MEMORANDUM

TO: Development Review Board
FROM: Mary O'Neil, AICP Principal Planner
DATE: July 20, 2021
RE: ZP21-450; 28 Sunset Cliff Road

File: ZP21-450 OG
Location: 28 Sunset Cliff
Zone: RL-W **Ward:** 4N
Parking District: Neighborhood
Date application accepted: May 22, 2021
Revised plan received: July 12, 2021
Applicant/ Owner: Maxx Garrison
Request: Demolish existing single family home; build new single family home with associated site improvements. A detached garage is proposed with an Accessory Dwelling Unit.

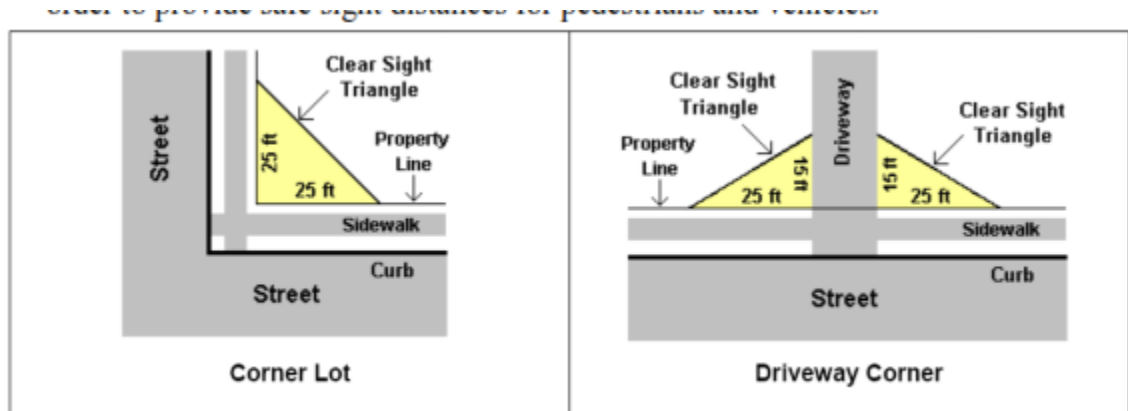
A 5' high cedar fence is identified on Plan C-3.0, This shall not encroach within the Clear Site Triangle (see image, above), and shall present a finished side to the street. **Affirmative finding as conditioned.**

9. The new driveway, fence and landscaping shall observe the Clear Site Triangle. The fence shall present a finished side to the street.
10. Per NFPA Fire Code, *New and existing buildings shall have approved address numbers placed in a position to be plainly legible and visible from the street or road fronting the property.*
